Technical Note

Project:	SWIP, Stopgate Lane				
Subject:	Review of AQA & HHRA				
Author:	Atkins				
Date:	16/05/2022	Project No.:	5214359		
Distribution:	Jonathon Haine	Representing:	Lancashire CC

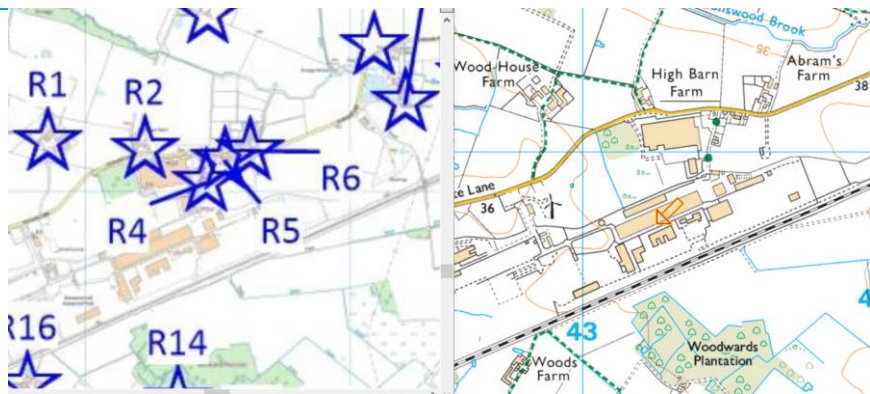
10	10.5.1	Construction Dust	The assessment has been completed in accordance with the appropriate IAQM methodology. A detailed review of the construction dust assessment is not within the scope of this review however, the assessment appears to be adequate, with final determination of dust risk impacts given in Table 10.22 considered to be appropriate.	N/A
11	10.5.2	Construction Traffic	Screening criteria for assessment of vehicle emissions reference those within the IAQM Planning Guidance (2017) as appropriate. A review of the construction traffic assessment is not within the scope of this review.	N/A
12	10.6.1	Operational Traffic	Screening criteria for assessment of vehicle emissions reference those within the IAQM Planning Guidance (2017) as appropriate. A review of the operational traffic assessment is not within the scope of this review.	N/A
13	10.6.2	Odour	A review of the odour assessment is not within the scope of this review.	N/A

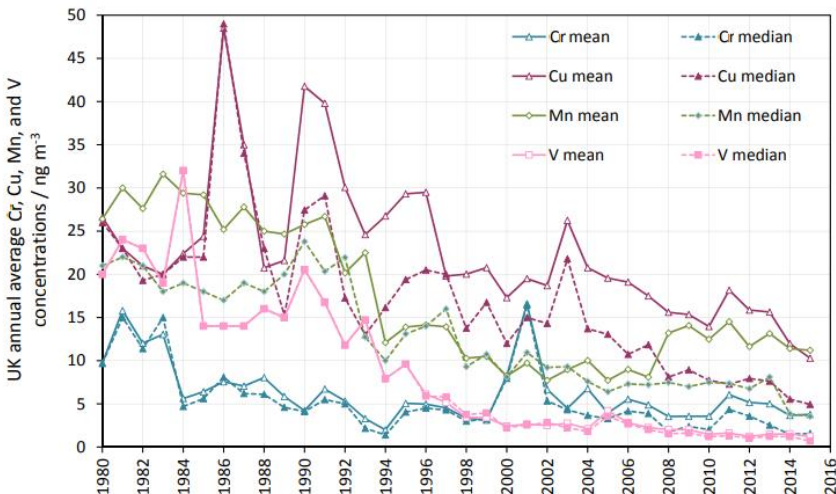
79	4.1.1	Table 4.1	There is a substantial difference (x 25 or more) between the maximum point of exposure and receptor R4 which suggests dispersion may not	Applicant to clarify how stack height was determined

Item	Reference	Topic	Atkins comment	Action
			have been optimised through stack height. See comments under 3.4 above.	
80		Table 4.2	Unitised deposition rates provide lower values than may typically be expected. i.e. for a concentration of 50 µg/m ³ we would expect a deposition rate in g/m ² /year of the same order of magnitude or 2 to 3 times higher for a deposition velocity of 0.01 m/s (suitable for fine particles). It is the case that the AERMOD calculation of wet deposition tends to give negligible results, whereas ADMS can give much higher deposition rates.	Applicant to review and confirm relationship between concentration and dry/wet deposition is as expected
81		Table 4.4	Results at the closest receptor, R4, are a small fraction of the TDI (1%) despite a number of conservative assumptions made in the assessment. This allows for a large margin for error in aspects like deposition, intake rates, exposure assumptions etc without affecting the conclusion.	N/A
